A46 Newark Bypass

Scheme Number: TR010065

7.58 The Applicants Responses to Comments Received at Previous Deadlines

The Applicants Responses to Comments Received at Previous Deadlines

CLIENT	Peridot Solar		
PROJECT	Kelham Solar Farm		
LOCATION	Land off A617, Kelham, Newark, Nottinghamshire		
TITLE	Proposed PV Layout		
DWG NO.	PS-KELHAM-GA-01	REV	K

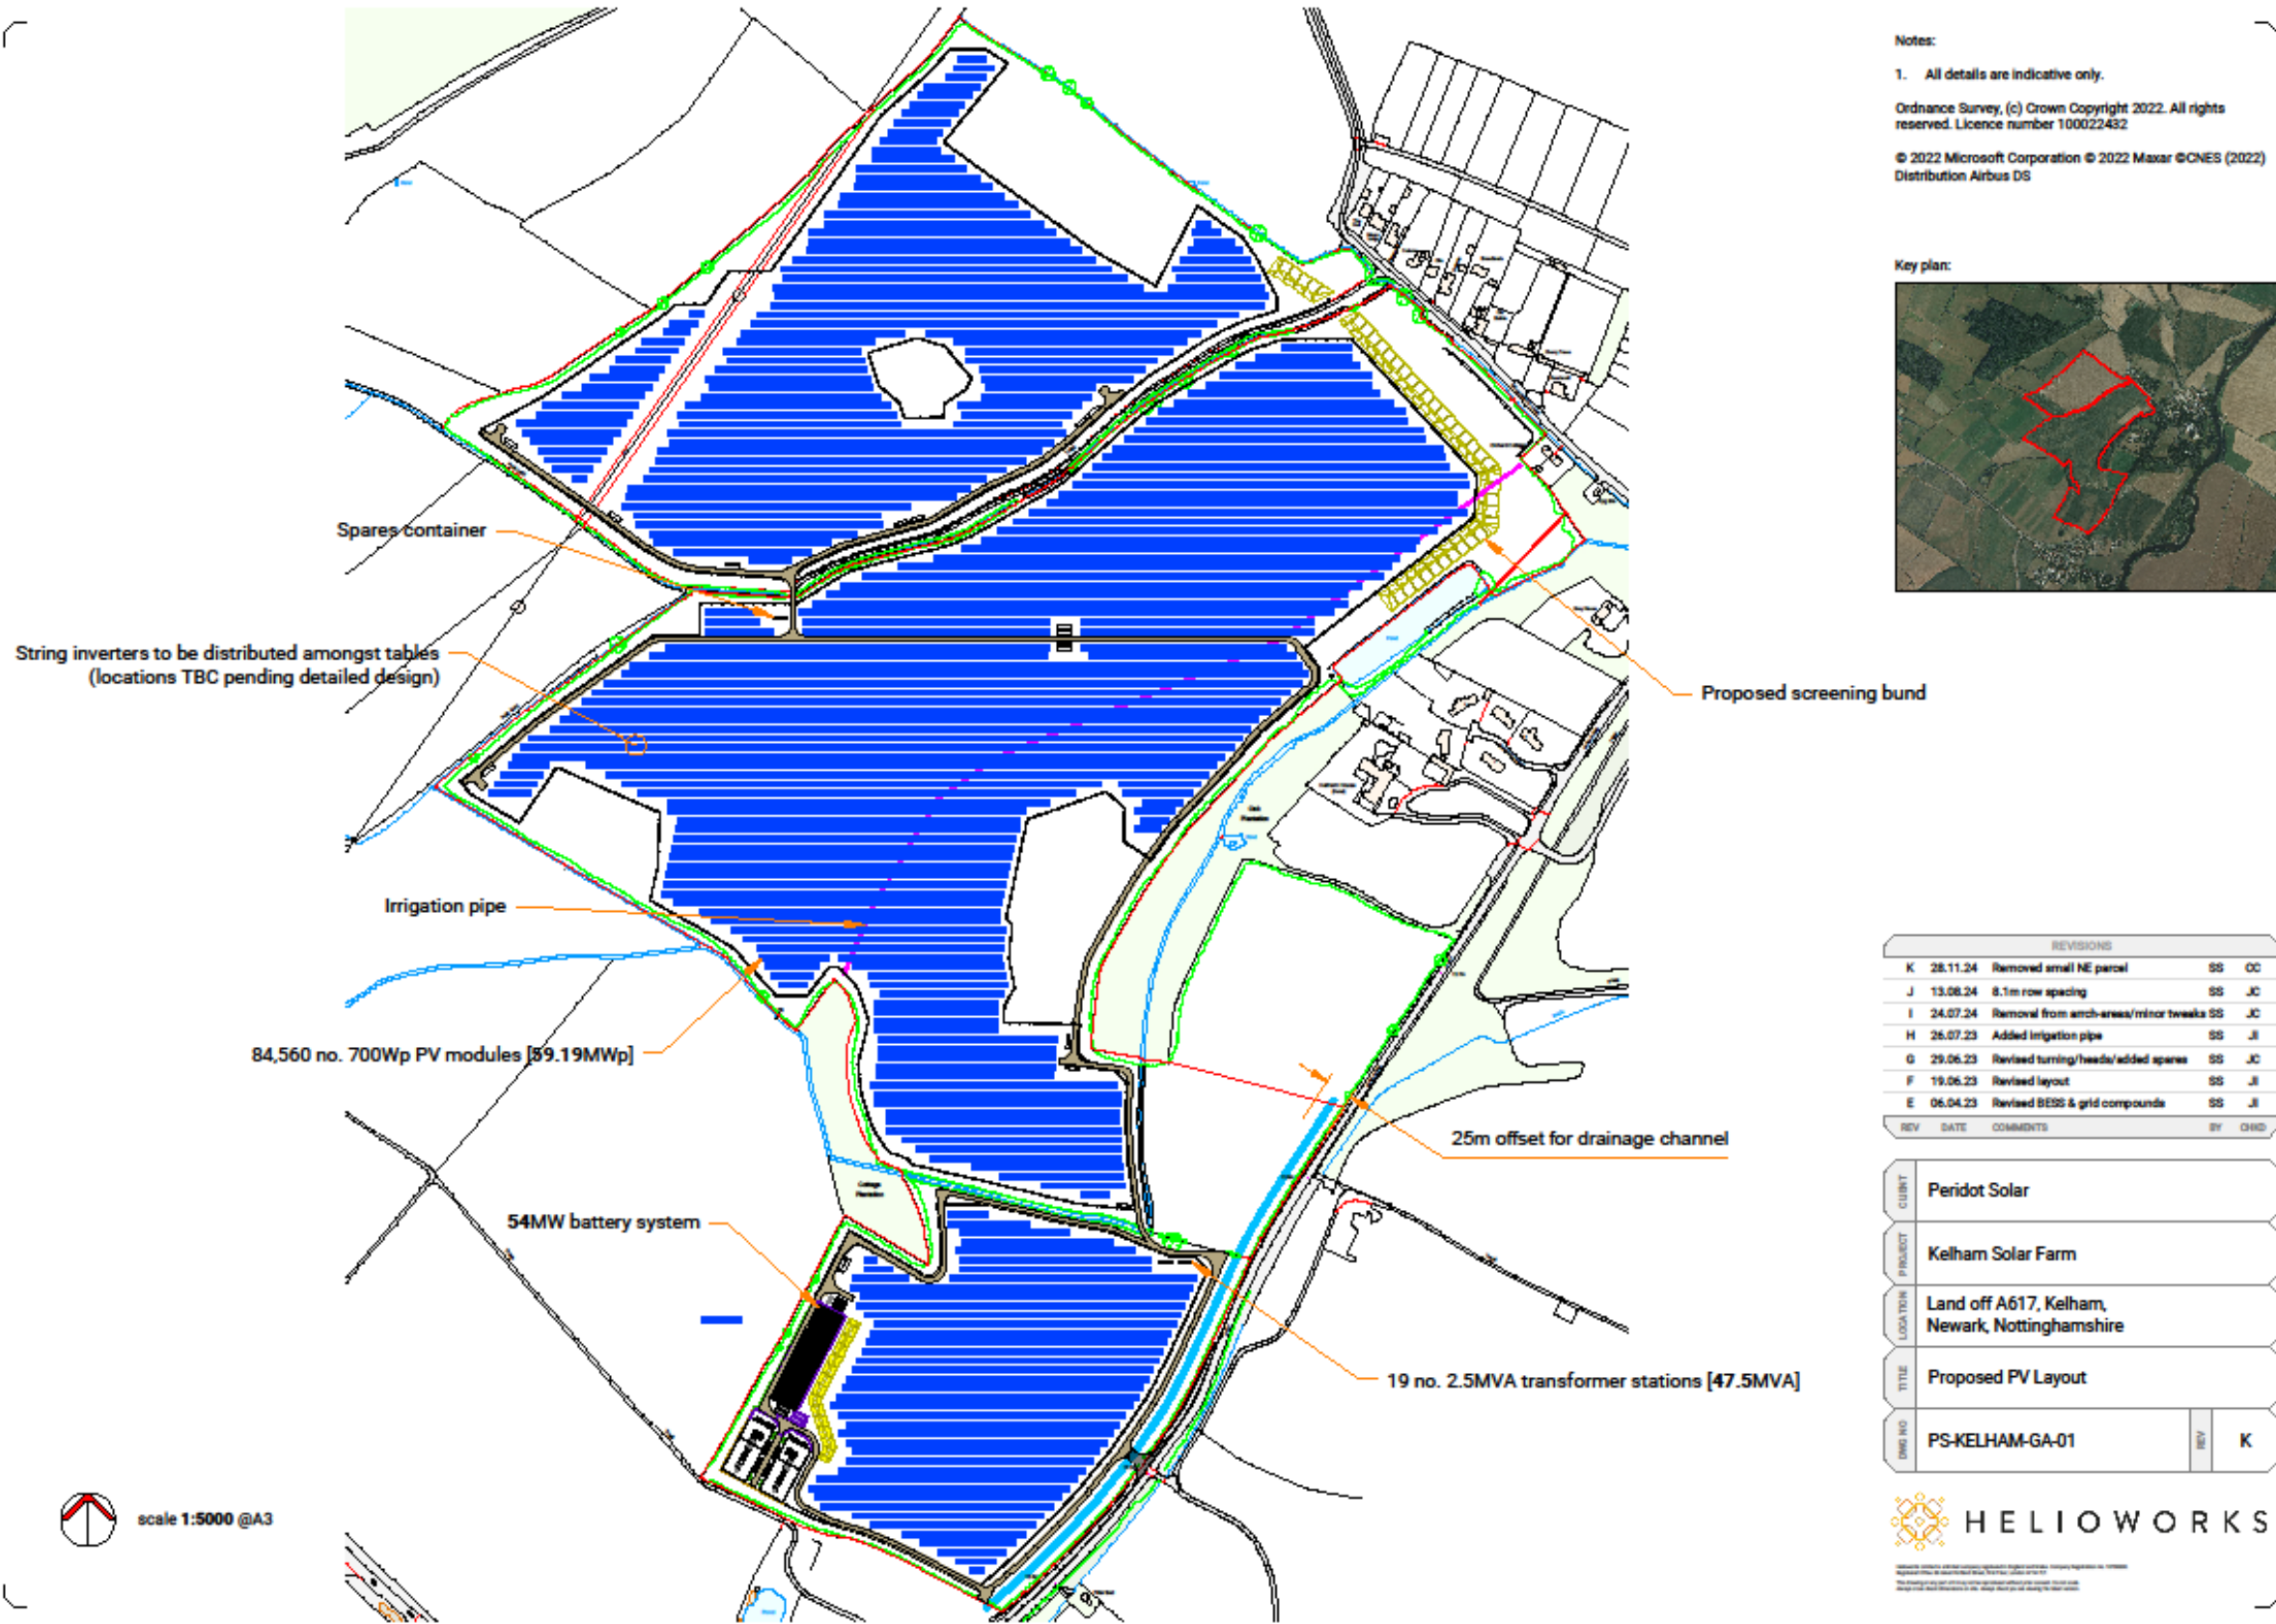
3.1	Q3.1.3 Kelham and Averham FCA Ongoing Maintenance We note the Applicant's response to this question and we have the following comments: We understand that maintenance is secured under Requirement 14. However, due to the maintenance of aspects of the FCAs being fundamental to their function (clearing of debris in flow conveyance structures) to ensure water can free flow to and from FCA areas, we need to confirm that sufficient maintenance will be undertaken through a maintenance plan as part of the DCO application. Our WR [REP2-043] comments on issue ref. EAFR-006, and our response to Q15.1.11 [REP2-042] provides more details on why a maintenance plan is necessary.	Article 4 (Maintenance of drainage works) in the Development Consent Order [REP2-002] provides that nothing in the order affects the existing responsibility for the maintenance of any works unless otherwise agreed in writing between the Applicant and the person responsible. The Applicant will provide a blockage related maintenance plan for culverts into the Kelham & Averham Flood Compensation Area in the Third Iteration Environmental Management Plan, which is secured by Requirement 4 and on which the Environment Agency will be consulted. EAFR-006 within [REP2-043] made reference to the interface with the proposed Kelham Solar Farm (Planning Application Ref 23/01837/FULM). At ISH 3 [EV9-003] both Peridot Solar and Newark and Sherwood District Council stated that a revised plan for the Solar Farm had been submitted and that this had removed the solar panels from the FCA. The Applicant received a copy of this plan (PS-KELHAM-GA-01) on the 10 th December and have included it in Appendix A of this document. Peridot Solar have confirmed that this revised plan was submitted to Newark and Sherwood District Council on the 2 nd December. The plan shows that the solar panels have been removed from the eastern section of the Kelham FCA, Work No 125, as shown on Sheet 7 of the Works Plans [REP3-003]. The interface between the solar panels and the FCA has therefore been removed.

Environment Agency - Comments at Deadline 3 – 26 November		The Applicant's Response
3.2	<p>Q4.0.20 Effect of the Proposed Development on Proposed Solar Scheme</p> <p>We note the Applicant's response to this question and our comments provided in our response to this question in ExQ1 [REP2-042] remain applicable. Please also refer to our response to Q5.0.10.</p>	Plan PS-KELHAM-GA-01 has been received from the solar farm developer, which removes the solar panels proposed for the FCA site from their design. This is attached as Appendix A. Further engagement is to take place prior to Deadline 5, when an updated position will be provided.

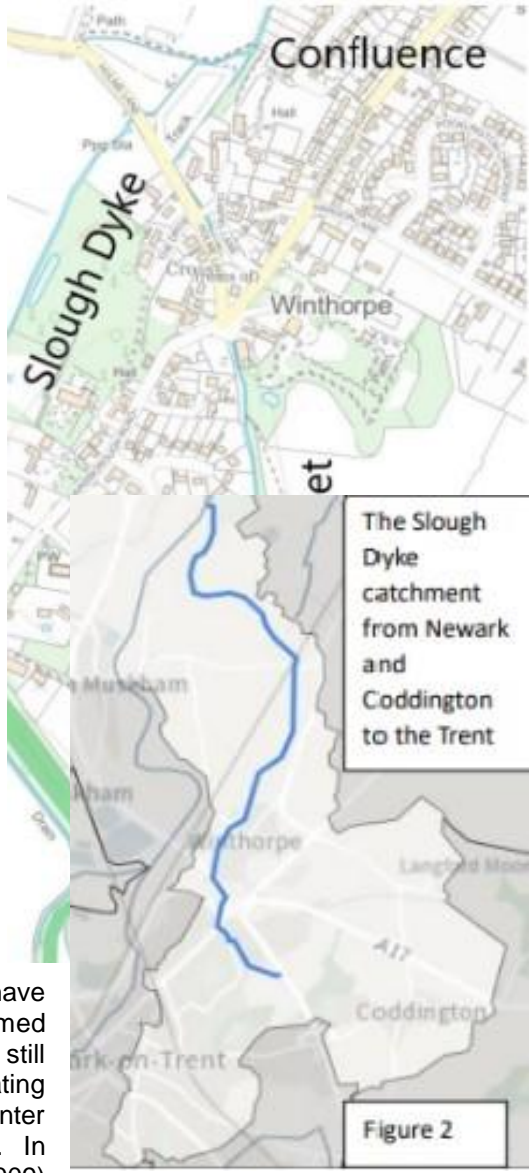
7 In our submissions to National Highways and the Planning Inspectorate we have several times referred to the inadequate attention paid to the effects that storm runoff will have within Winthorpe. In our Relevant Representation (RR-071) we said:- Winthorpe is the location of two of the watercourses referenced in the Environmental Statement – Chapter 13 Road Drainage and Water Environment, the Slough Dyke and The Fleet. Examination of the plans in Engineering Plans and Sections Part 5 – Drainage Engineering Plans, reveals that these water courses are the recipients of the proposed road drainage from 40% of the Bypass, from the ECML rail bridge to Winthorpe Roundabout. The design and analysis provided in National Highways reports concentrates almost exclusively on the Slough Dyke. The Fleet is only referred to as a geographical feature into which surface water from the road would drain. Again, in our Relevant Representation we said:- We would like to first address the geography of these two watercourses and the confusion which arises within the DCO submissions where the names Slough Dyke, Slough Dyke/Fleet, the Fleet, Tributary of the Fleet and Unnamed Watercourse 1 are used randomly. The Slough Dyke is a river under the management of the Environment Agency, its origin is in the Bowbridge area of Newark and it outfalls to the Trent near Cromwell Weir. The Environment Agency clearly reference it as The Slough Dyke and not as The Fleet. It is proposed that all the road drainage on the west side of the A1 up to the rail bridge will drain to this watercourse. The Fleet, referred to in the DCO submission as 'Tributary of the Fleet', Unnamed Watercourse 1 and occasionally as the Fleet which is managed by the Trent Valley Internal Drainage Board and referred to by them as 'the Winthorpe Airfield Drain' rises in Coddington and flows via a culvert under the A46 to outfall to the Slough Dyke in Winthorpe. Virtually all of the new road surfaces east of the A1 are scheduled to drain to this water course. National Highways have acknowledged that the Fleet/ Tributary of the Fleet/ Unnamed watercourse 1 and Winthorpe Airfield Drain are the same. They still have chosen to ignore the hydromorphology of the catchment relating to the road scheme whereby flood water from the road will enter Winthorpe at two different locations as shown here in **Figure 1**. In their Response to the Relevant Representations (7.10, REP1-009) they state:- Whilst the Fleet is considered to be the waterbody from where the Slough Dyke converges with the watercourse (tributary of the Fleet (1) (as referenced in Chapter 13 (Road Drainage and Water Environment) of the Environmental Statement [APP-055]), from a WFD perspective as shown by the Environment Agency Data Catchment this is the 'Slough Dyke Catchment (trib of Trent) waterbody (GB104028053111).' Referring to the occasional naming of the Slough Dyke between Winthorpe and the Trent outfall as 'The Fleet'. **Figure 2** shows what the Environment Agency considers to be the Slough Dyke catchment, studiously avoiding any hydrological and pollutant inputs from the east of the catchment. Thus any detailed study of what happens in Winthorpe is avoided. A possible influence on the omission of deeper study is the clear error in National Highways data gathering whereby they confuse the Fleet, as flows though Winthorpe, with another waterbody, the Fleet Upper Catchment.

<p>The impact of any runoff from the Slough Dyke catchment will affect Winthorpe in a much more specific way than that suggested in National Highways' design and analysis. The plan below clearly shows that water flowing into and through Winthorpe comes from two distinct catchments as shown in Figure 4 below.</p>		<p>As described above the Scheme drainage is attenuated within ponds and the flow within the Slough Dyke will not exceed existing flows up to a 1:100 plus climate change rainfall event.</p>
<p>Furthermore, it is the Fleet catchment flows which will cause the most damage in Winthorpe as Figure 1 shows how it is the Fleet which flows through the heart of the village whereas the Slough Dyke follows its north western boundary. Whilst there would be flood impacts on Holme Lane, including to Severn Trent Water's sewage pumping station, resulting from Slough Dyke flows the worst of any flooding from any storm runoff would be from the Fleet catchment affecting the village centre, including the Lord Nelson public house and Holme Lane. As this series of images shows not only is the Fleet very shallow in this location but it is constrained to flow under the main village street and for some distance down Holme Lane in a concrete box culvert. The limited flow capacity of this culvert would result in excess flows very easily overflowing the Fleet bank and flooding the Lord Nelson, Holme Lane and the historic properties nearby. These images show how vulnerable the Lord Nelson public house is to flooding from the Fleet, the village green under which the Fleet is culverted and the intimate relationship between the Fleet and the historic centre of the old village.</p>		<p>As described above the Scheme drainage is attenuated within ponds and the flow within the watercourse known as 'the Fleet' or the 'Tributary of the Fleet (1)' will not exceed existing flows up to a 1:100 plus climate change rainfall event.</p>

The watercourse referred to as 'the Fleet' in Figure 1 of the Think Again response is assessed in Chapter 13 (Road Drainage and Water Environment) of the Environmental Statement [APP-057] as 'Tributary of the Fleet (1)'. We acknowledge the difference in naming convention of the watercourse but this does not alter the conclusions of the assessment, which are still considered to be valid. The Applicant has provided attenuation within this area for additional highway run-off for a 1:100 plus climate change rainfall event. Currently there is no highway drainage attenuation on the A46, with all highway drainage assets outfalling directly into the Slough Dyke and the watercourse known as 'the Fleet' or the 'Tributary of the Fleet (1)'. The Applicant has provided attenuation basins for the additional hardened surface and embankment/cutting slopes and limited the outfall rate into the Slough Dyke or the watercourse known as 'the Fleet' or the 'Tributary of the Fleet (1)' to the highest of the existing green field run-off or 5 litres per second in order to not increase the volume of water that enters the watercourses during a rainfall event. In some cases, the attenuation is provided to existing assets and new assets outfall directly to existing outfalls in order to make the location, size and maintenance of the new attenuation basins as efficient as possible. The approach taken to use green field run-off rates is conservative and with the additional use of swales in place of pipes will actually reduce the rate of water entering these water courses when compared to the existing situation.

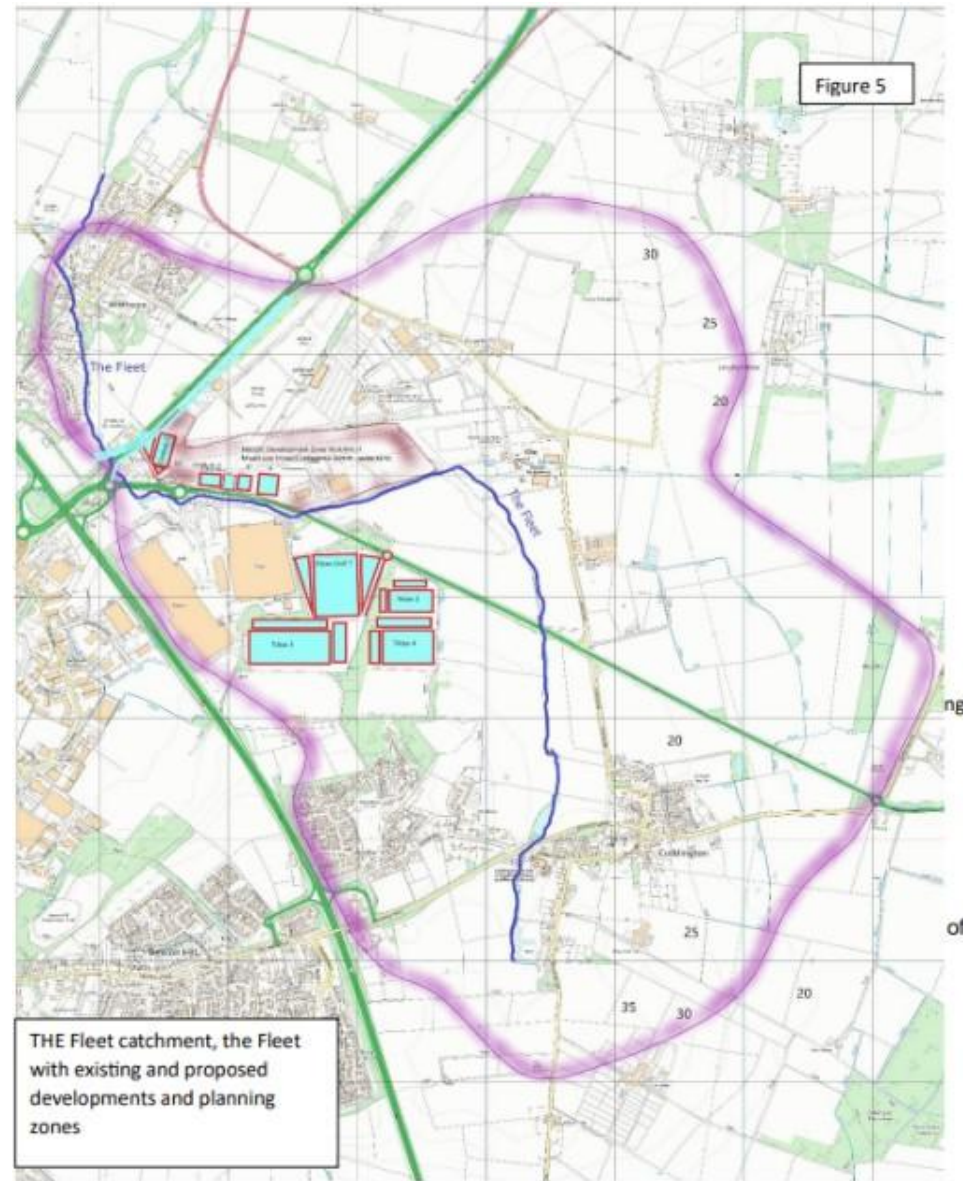
The map below, **Figure 5**, outlines the catchment of the Fleet from the headwaters on Balderton Road, Coddington to the confluence with the Slough Dyke. Whilst it is by no means as urbanised as the Newark catchment zone it is rapidly becoming a significant zone of industrial development, with associated roads, roundabouts and HGV manoeuvring area, all of which drain, by one means or another, into the Fleet and on through Winthorpe.

Each new 'Sustainable' feature is being added piecemeal to the Fleet catchment without any overview as to whether there are any combined effects. Indeed it is not clear to us whether the Trent Valley IDB or Notts County Council as the Lead Local Flood Authority has any competence to approve or monitor these drainage schemes. In this way Winthorpe is being affected by a multitude of additional sources of flood water without any comprehensive overview of the holistic risk.

The Applicant is not able to comment upon the other developments in the area. As highlighted above The Scheme drainage has been attenuated such that flows into the watercourse known as 'the Fleet' or the 'Tributary of the Fleet (1)' and Slough Dyke do not exceed existing.

The Applicant is not able to comment upon the other developments in the area. As highlighted above, the Scheme drainage has been attenuated such that flows into the watercourse known as 'the Fleet' or the 'Tributary of the Fleet (1)' and Slough Dyke do not exceed existing.
